Subject: NPDES Permit Renewal
SMIP No. 6477SM5
Hamilton & Washington Townships
Adams and Franklin Counties

On behalf of Specialty Granules Inc (SGI), URS is responding to the Pennsylvania Department of Environmental Protection, (PADEP) comment letter dated July 13, 2012 concerning the NPDES Permit Renewal for the above referenced subject. This letter provides URS' response to PADEP's July 13, 2012 comment letter. The attached NPDES Permit No. PA0009059 Application Final Addendum Report dated October 25 is considered comprehensive and complete to address all of PADEP's comments on this matter, including the original PADEP comment letter dated April 25, 2012. The attached report replaces URS' prior response submittal dated May 24, 2012, as some calculations and conclusions have been revised to reflect the entire scope of comments received from PADEP.

NPDES PERMIT NO. PA0009059 APPLICATION FINAL ADDENDUM REPORT

**Charmian Facility
Hamiltonban Township,
Adams County, Pennsylvania**

NPDES PERMIT NO. PA009059 APPLICATION ADDENDUM REPORT			
LOWER MILL PONDS DRAINAGE AREAS NPDES PERMIT STUDY			
FIGURE 2 SPECIALTY GRANULES INC. BLUE RIDGE SUMMIT, PA ADAMS COUNTY, PENNSYLVANIA			
Prepared By:	BAS	Checked By:	MDP
Job:	20498083	Date:	11/09/11

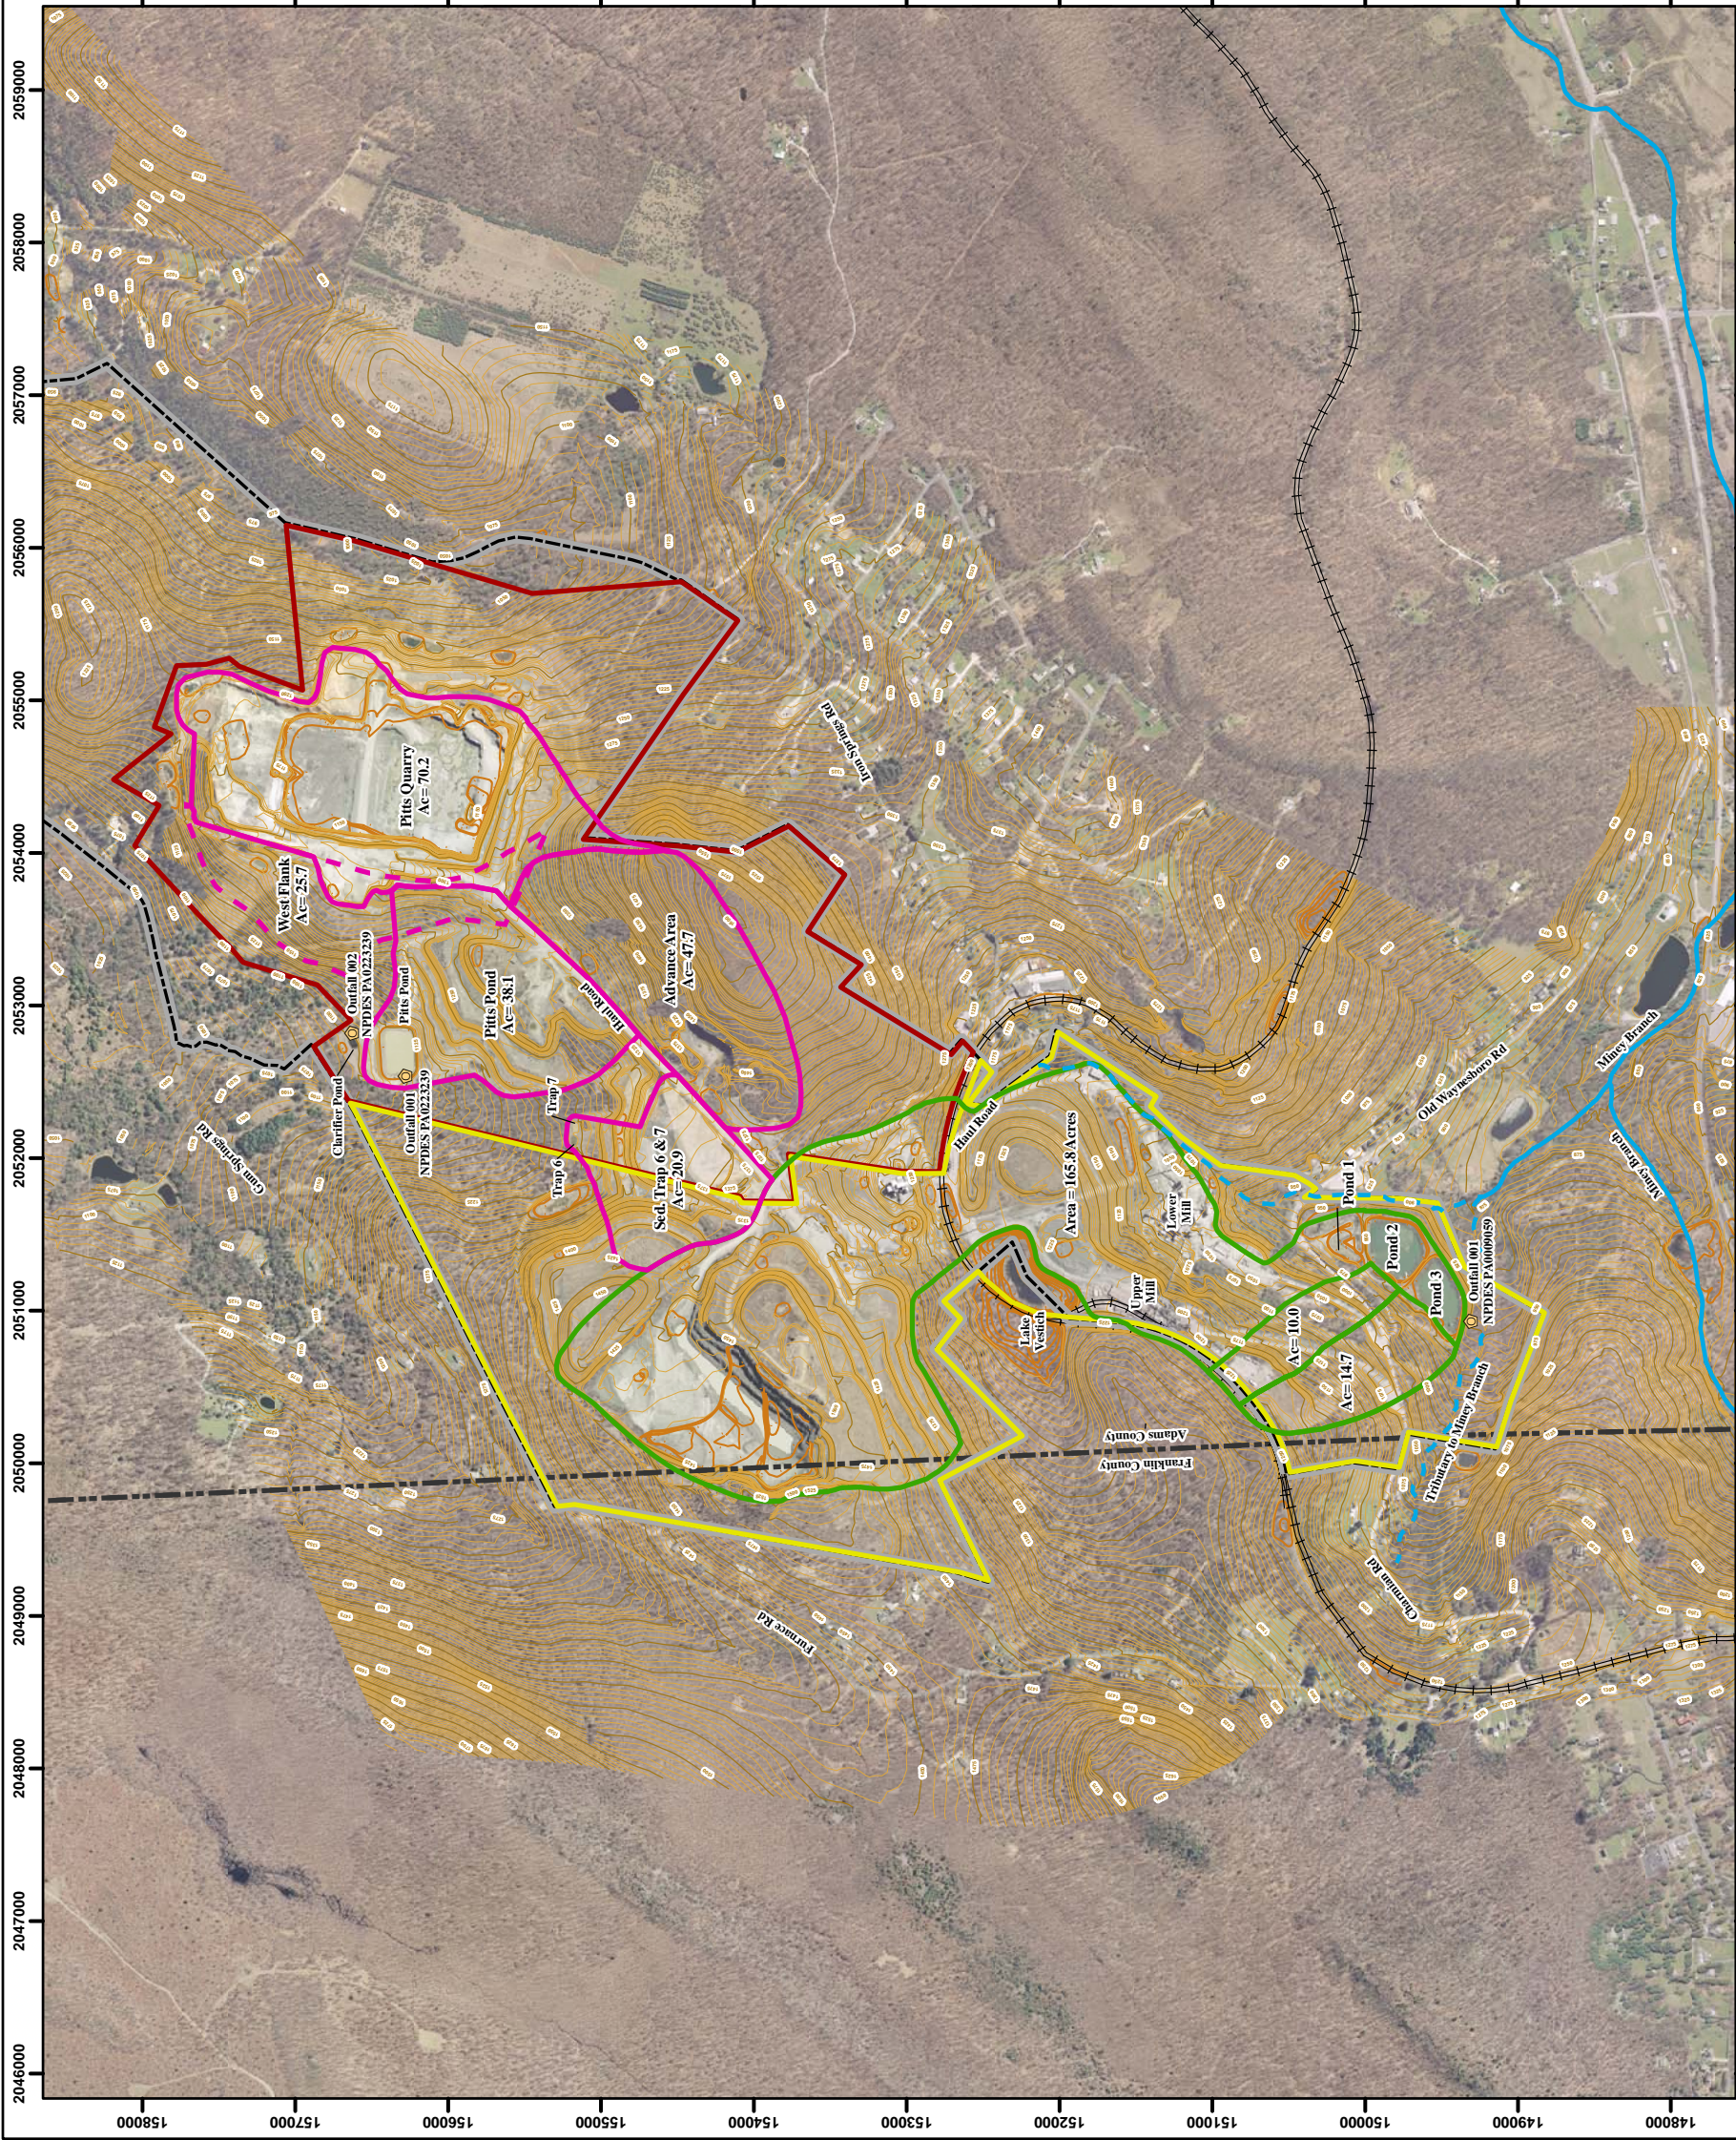
- 1.) On page 1, please clarify the drainage area for the Pitts Quarry. The 70.2 acres noted on Figure 2, Lower Mill Ponds Drainage Areas NPDES Permit Study, is smaller than the drainage area outlined on the Figure 2 Map.

JOB NO.: 20498083	SCALE: 1"=150'
SHEET:	DATE: 9/24/12
FIGURE 3	REV.:

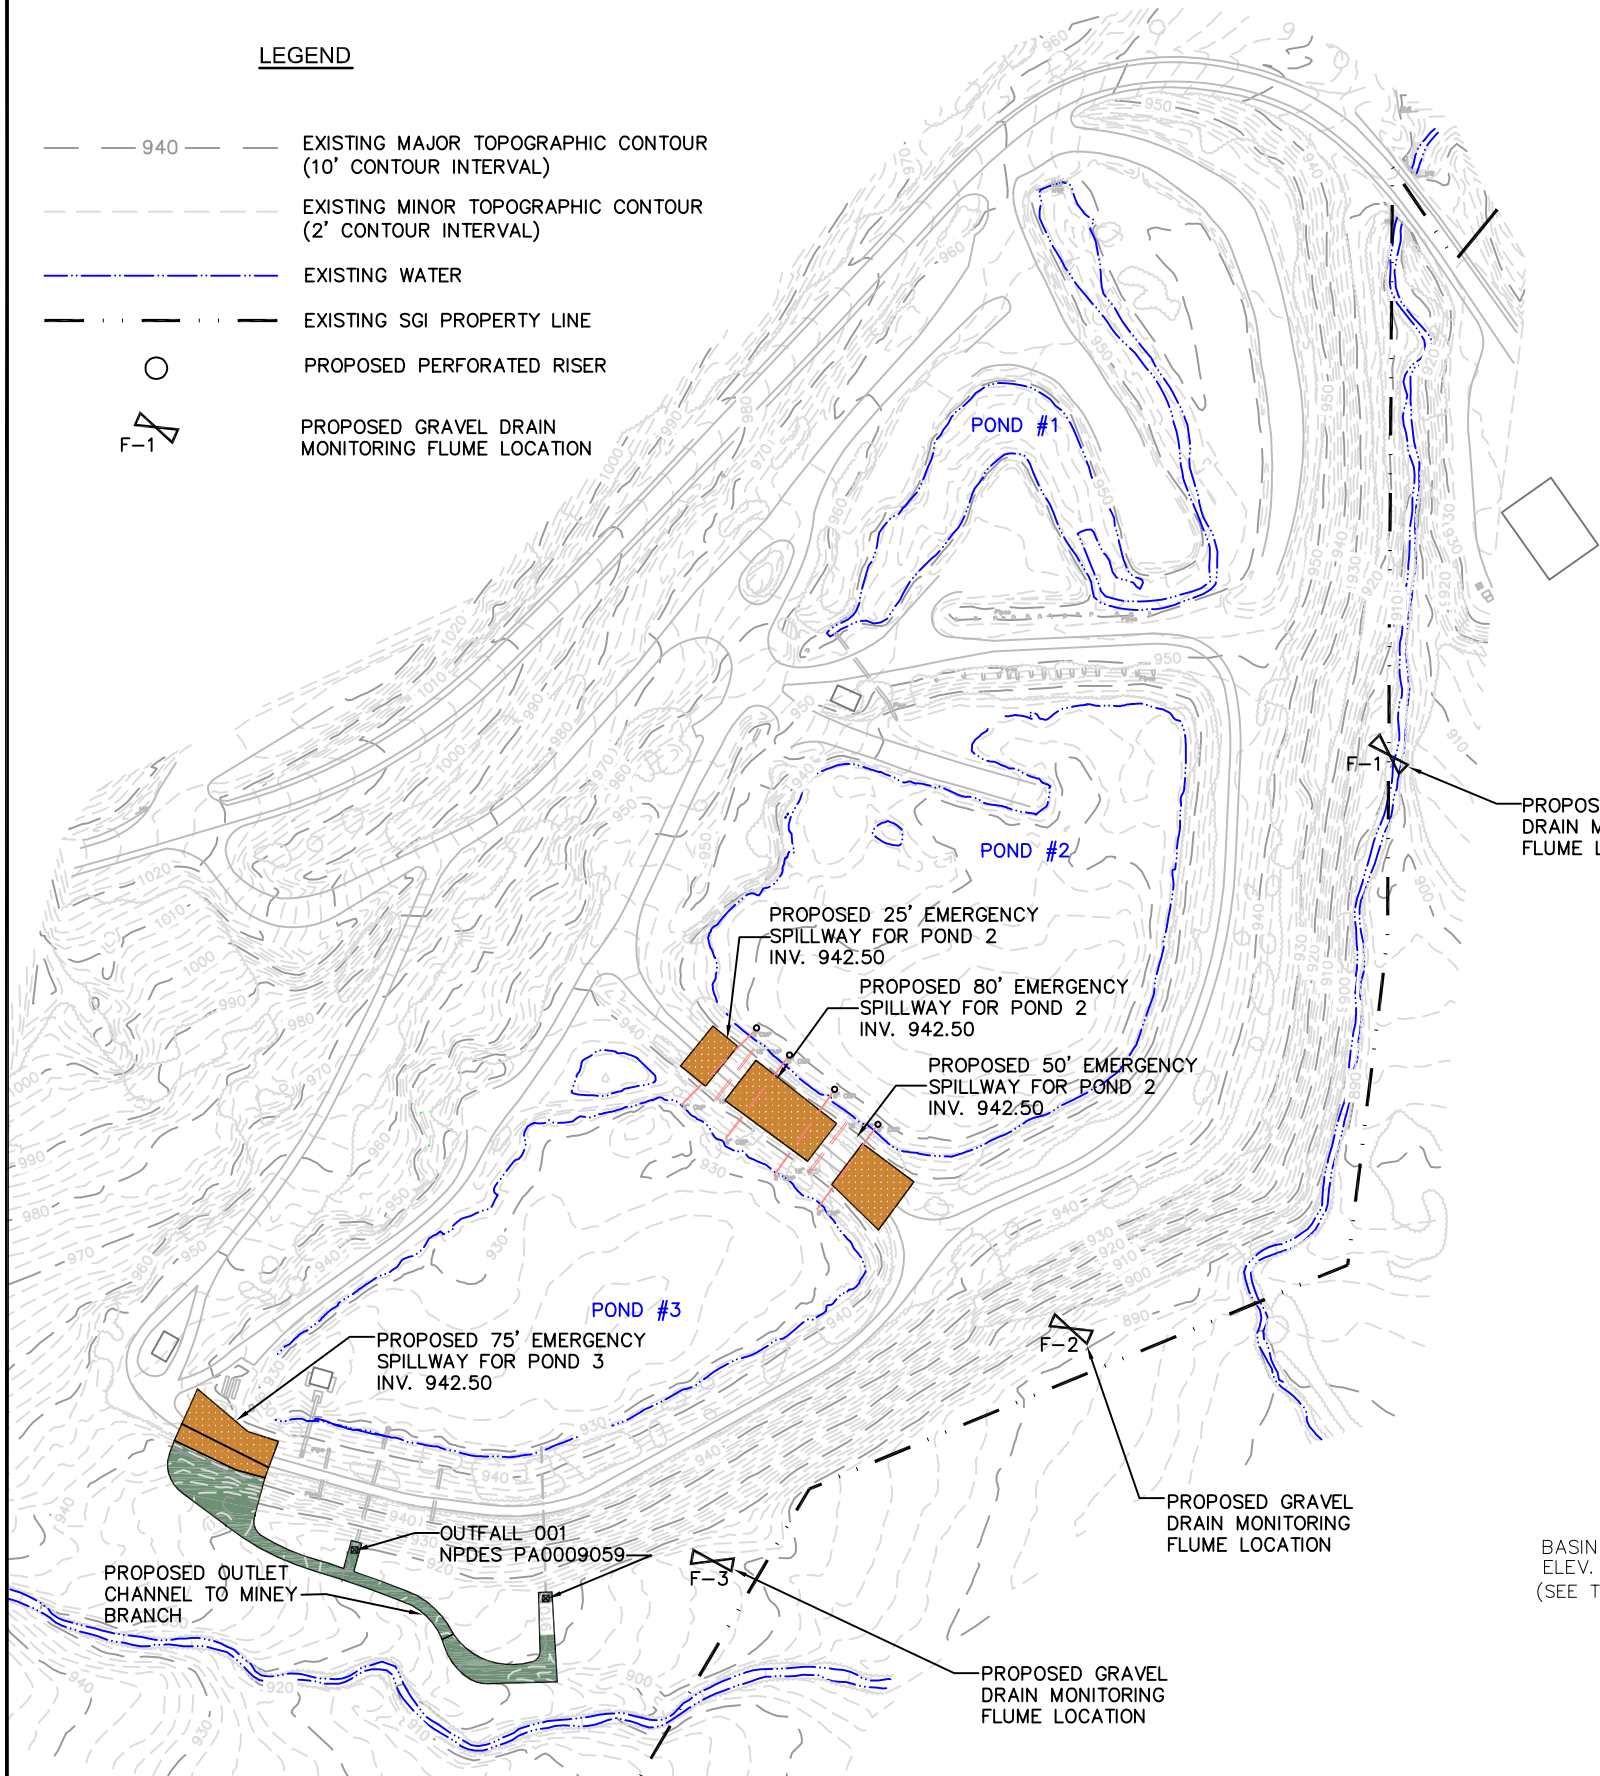
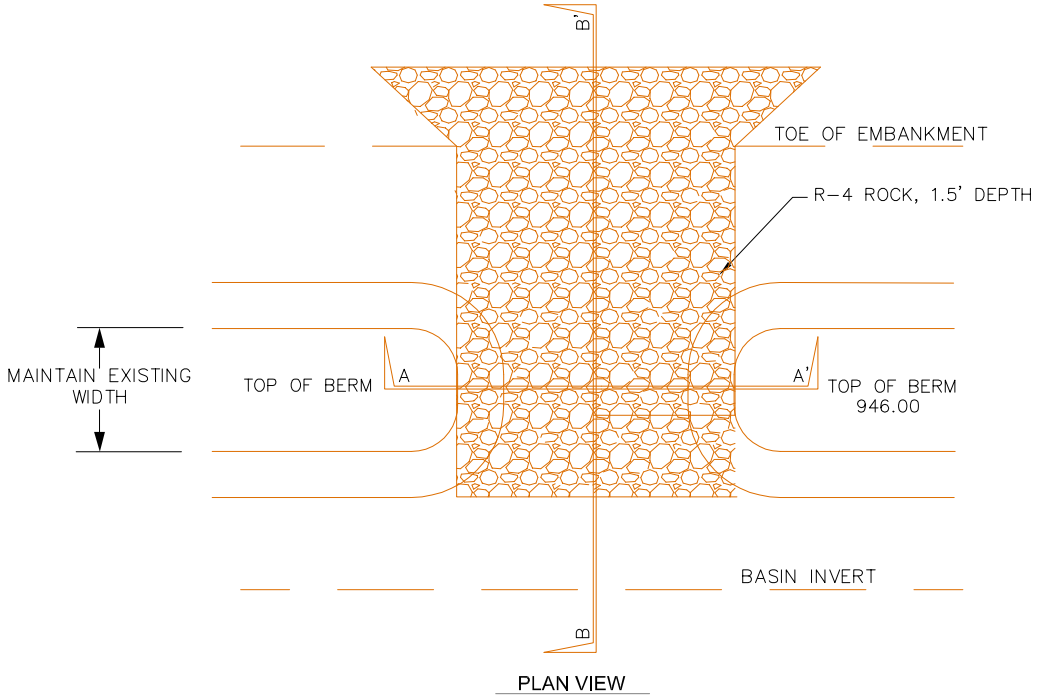
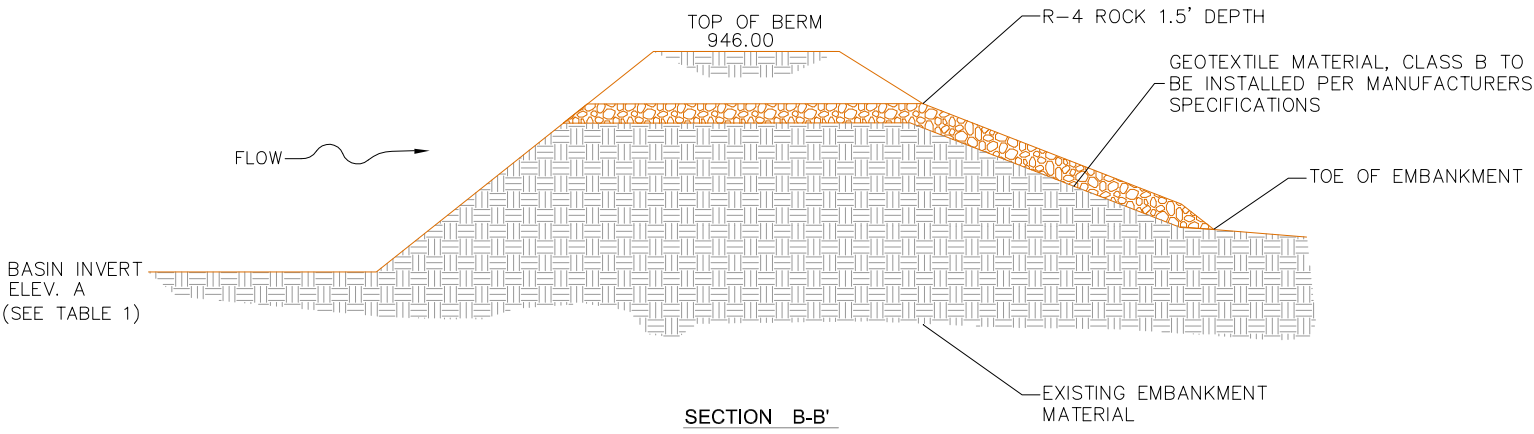
1.) Until weirs are constructed downstream of Sediment Basin # 3 outfalls and dates and flow rates provided it is hard to determine the average monthly discharge rate required for the NPDES permit.

SGI plans to construct measurement flumes at three locations downstream of Pond No. 3 to monitor flow discharges. Figure 3 in the attached report is a plan view and construction details of the proposed weir locations for review.

JOB NO.: 20498083	SCALE: N.T.S.
SHEET:	DATE: 9/24/12
FIGURE 4	REV.:

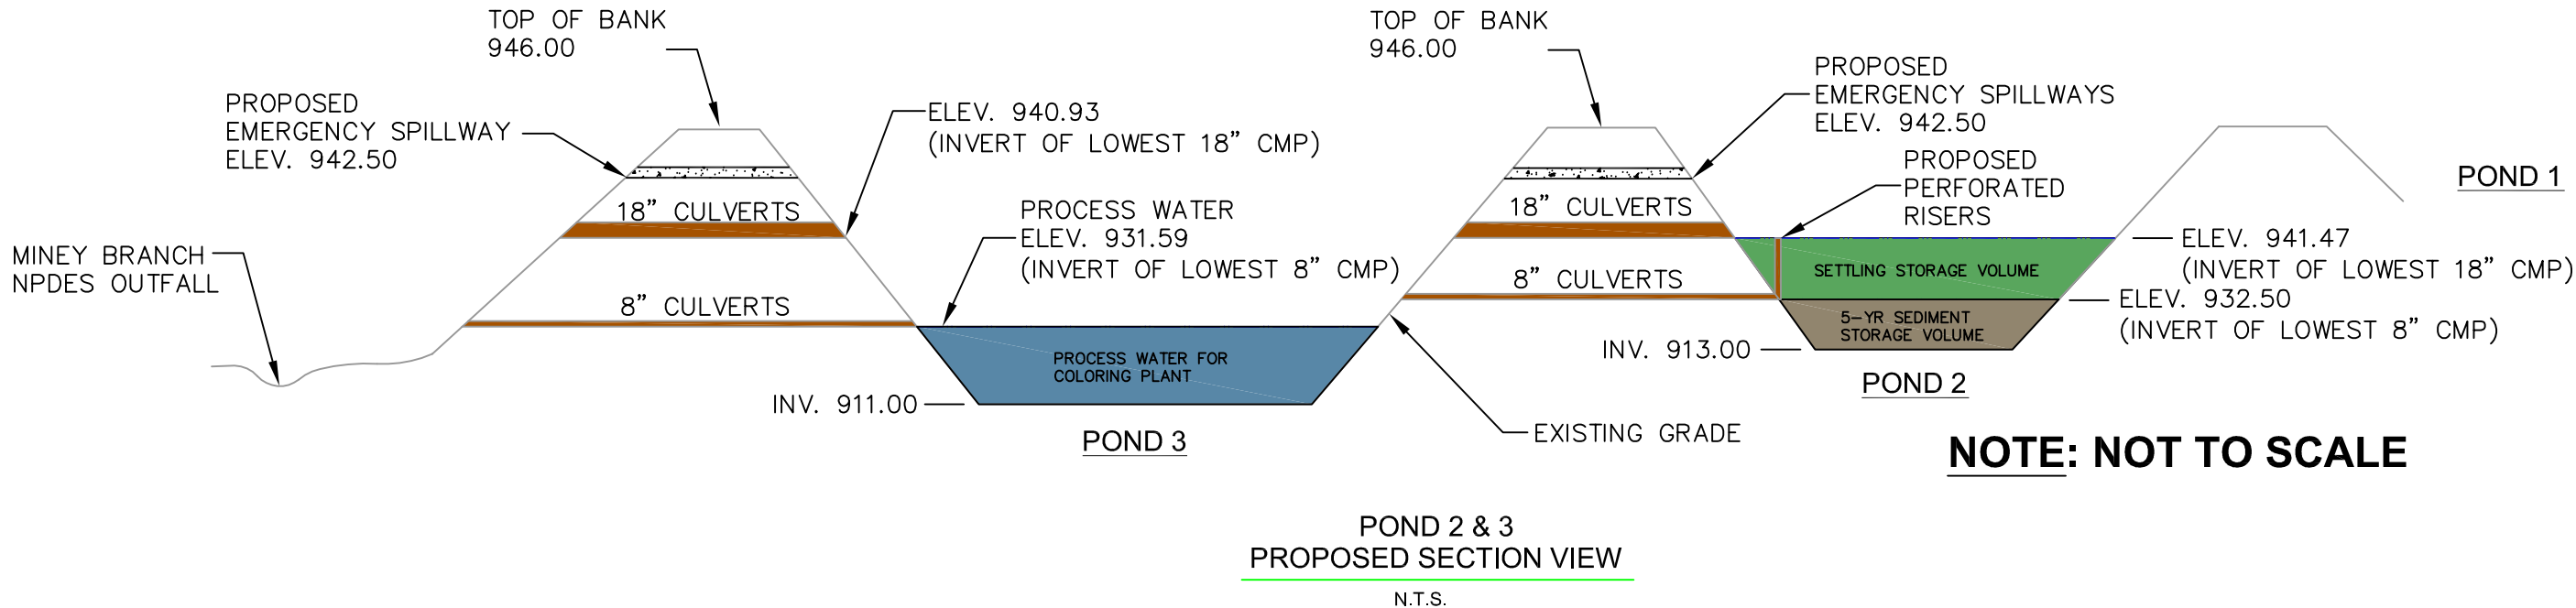
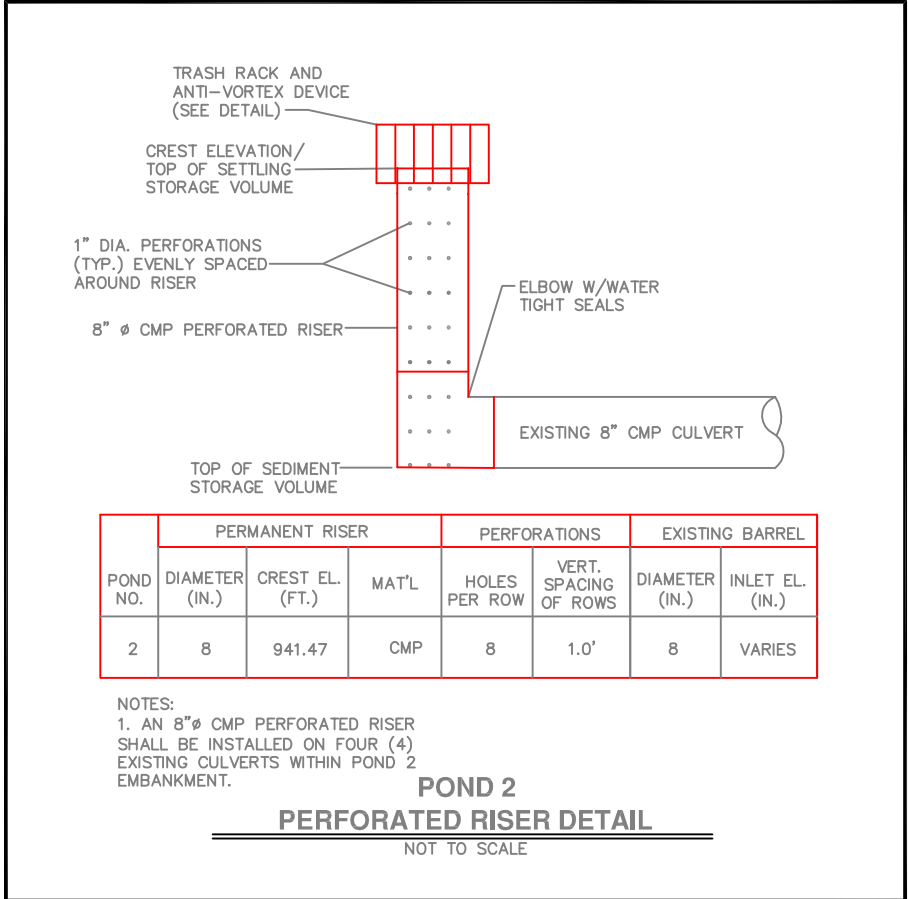
- 1.) Please clarify how the Lower Mill Pond System qualifies for a dam permit waiver as provided for a Chapter 105, Section 12 – Waiver of Permit Requirements under Paragraph 6. Does the Lower Mill Pond System meet all the requirements of Chapter 102 as it relates to erosion and sediment control? Does the Lower Mill Pond System have a design emergency spillway that meets the Chapter 102 requirements? Do the ponds have dewatering pipes to lower the pond elevation to the sediment storage level to allow sufficient storage volume? If the ponds are always full at the elevations noted on the As-Built Plan for Sediment Ponds 2 and 3 – June 2011, then the ponds do not meet the required storage volume of 5,000 cubic feet per acre. Are the ponds certified by a professional engineer or registered land surveyor? Please provide this information to justify the Lower Mill Pond System meets all Chapter 102 requirements.***

- Pond 2 will be improved to include a spillway that can convey the Chapter 102-required 391-cfs (2cfs x Inflow Drainage Area) with 2-ft of freeboard. The freeboard is measured from the provided discharge water surface elevation to the top of bank. Pond 3 will be improved to include installation of a 75-ft spillway at an elevation of 942. With the proposed modifications to Ponds 2 & 3, the required discharge capacity will be met and the existing embankments will not have to be raised. Please reference the Addendum Report included with this submission for the design calculations and details.

The supporting calculations associated with the requirements of PADEP Chapter 102 and pond models are provided in Appendix C. Figures 3 and 4 depict the proposed improvements associated with Ponds 2 and 3. Tables 1 and 2 on Figure 4 depict the PADEP Chapter 102 requirements and peak water surface elevations for various design storms.
